TOWN OF GLASTONBURY

**GL-2010-27 CCTV Installation – Welles Turner Memorial Library
Bid Due Date: January 14, 2010 at 11:00 A.M.**

ADDENDUM #2 – dated 01-06-2010

Sketch 1
Attachment A
GL-2010-27

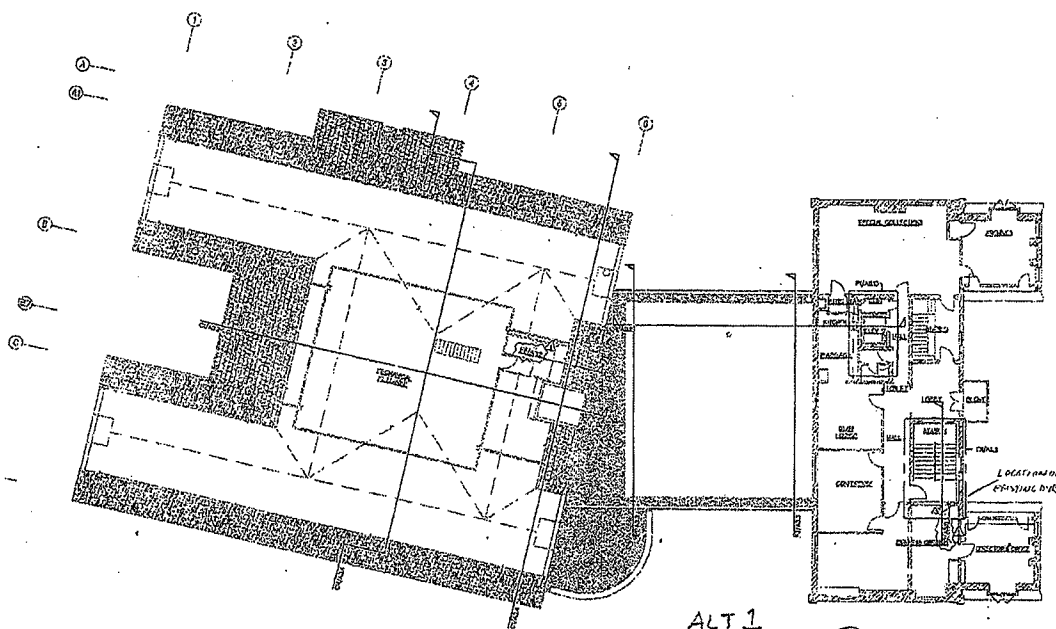
Sketch 1 Alternate 1 = Existing 9 ch DVR to be replaced with 16 ch 320 GB DVR

ALT 1
EXISTING 9 CH DUR
TO BE REPLACED WITH
16 CH DUR.

Sketch 2
Attachment A
GL-2010-27

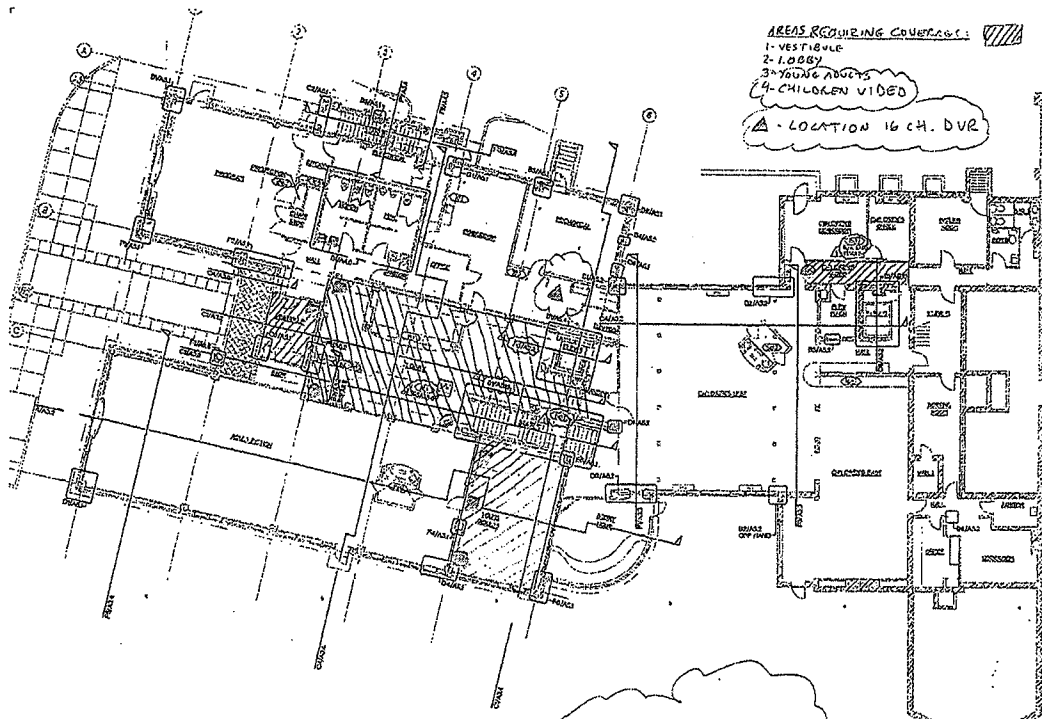
Sketch 2 Cameras this page: 3 Interior Base Bid,
5 Interior Alternate 1

This area will require three cameras. These are included in the total for Sketch 2 and are included in Alternate 1

CAMERAS THIS PAGE
3 INTERIOR BASE BID
5 INTERIOR ALT 1 R

Sketch 3
Attachment A
GL-2010-27

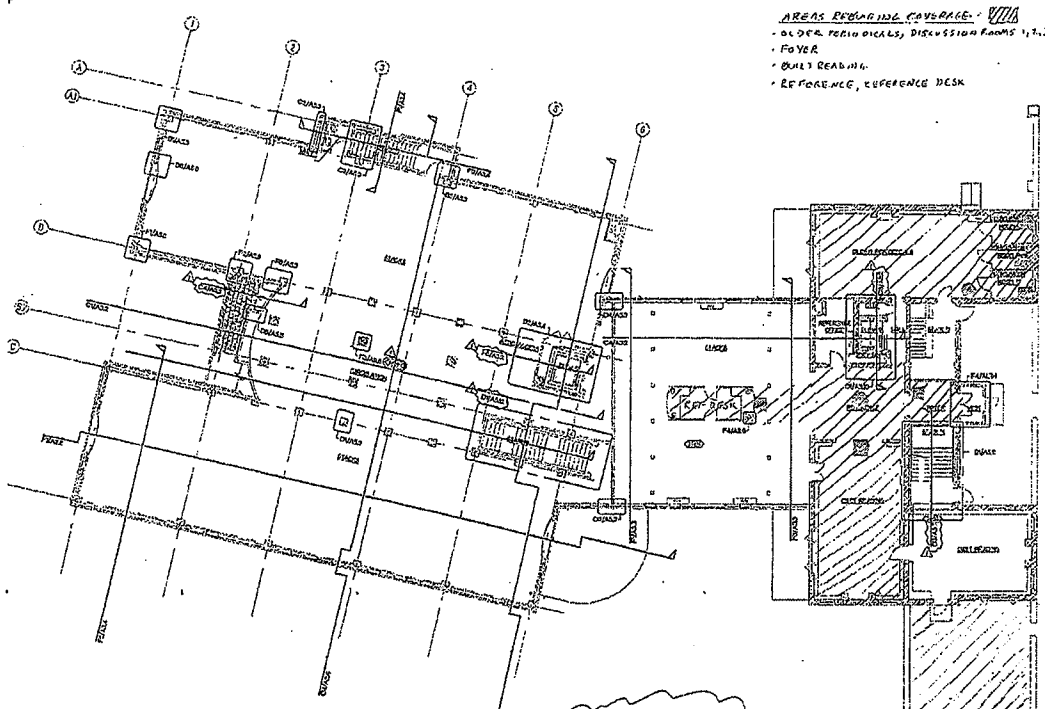
A camera is required in each of the study rooms, three in total to be included in Alternate 1. These are indicated on Sketch 3

Sketch 3 Cameras this page: 2 Interior Base bid,
5 Interior Alternate 1

CAMERAS THIS PAGE
2 INTERIOR BASE BID
5 INTERIOR ALT 1
